Access Compliance Report

Public Rights-of-Way

(Curb Ramps)

Intersection ID: 3246	Main Street: OLD_TIMBER_RD	Cross Street: SADDLE_PACE_LN	Location: SW
ADA ID: CC7C48D73622	Ramp Type: BlendTrans1	Initial Pass/Fail: Fail	Overall Compliance: No
			Severity Score: 18.75

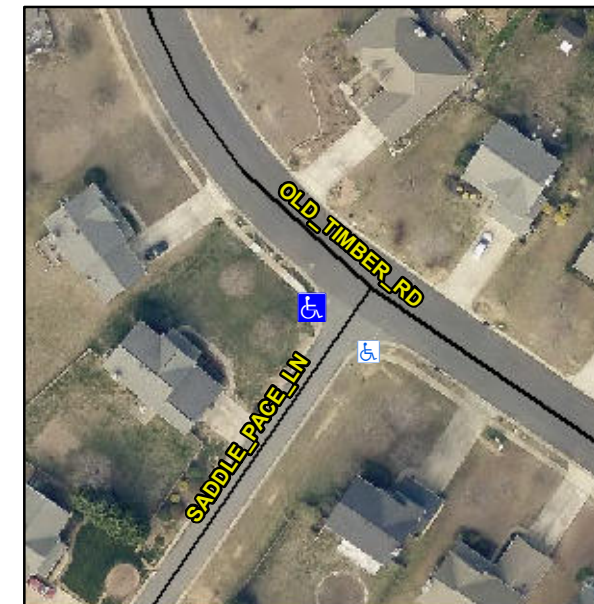
Not Found, R304.5.1, R304.5.3

Compliance	Description	Data	Compliance	Description	Data
N/A	Ramp Length (in)	52.5	Yes	BlendTrans Slope (%)	3.8
No	Ramp Width (in)	35.0	No	BlendTrans XSlope (%)	2.5
N/A	Flare Type LT	N/A	N/A	Flare Type RT	N/A
N/A	Flare Slope LT (%)	N/A	N/A	Flare Slope RT (%)	N/A
N/A	Flare Traversable LT?	N/A	N/A	Flare Traversable RT?	N/A
N/A	Landing Length (in)	N/A	N/A	DWS Provided?	N/A
N/A	Landing Width (in)	N/A	N/A	DWS Contrast?	N/A
N/A	Landing Slope (%)	N/A	N/A	DWS Length (in)	N/A
N/A	Landing X Slope (%)	N/A	N/A	DWS Full Width?	N/A
N/A	Landing Curb? (Y/N)	N/A	N/A	DWS Offset (in)	N/A
N/A	Shared Landing?	N/A			
N/A	Gutter Ponding?	N/A	N/A	Gutter Slope (%)	N/A
N/A	Gutter Lip Ht (in)	N/A	N/A	Gutter X Slope (%)	N/A
N/A	Painted X Walk1?	No	N/A	Painted X Walk2?	N/A
	X Walk 1 Direction	To SE		X Walk 2 Direction	N/A
	X Walk 1 Width (in)	N/A		X Walk 2 Width (in)	N/A
	X Walk 1 Slope (%)	8.5		X Walk 2 Slope (%)	N/A
	X Walk 1 X Slope (%)	1.9		X Walk 2 X Slope (%)	N/A

N/A	Ramp inside XWalk1?	N/A	N/A	Ramp inside XWalk2?	N/A
	Road Slope (%)	1.9		Clear Space?	N/A
	Road X Slope (%)	8.5	N/A	Clear Space to XWalk (in)	N/A
N/A	Any Obstructions?	N/A	N/A	Storm Grate/Utility Hazard?	N/A
	Obstruction Type			Storm Grate/Utility Type	
		N/A			N/A
			Yes	Surface Condition? (G/P)	Good
			No	Curb Slope (%)	7.8

Remove & Replace Curb Ramp With Two New Directional Ramps or Equivalent.
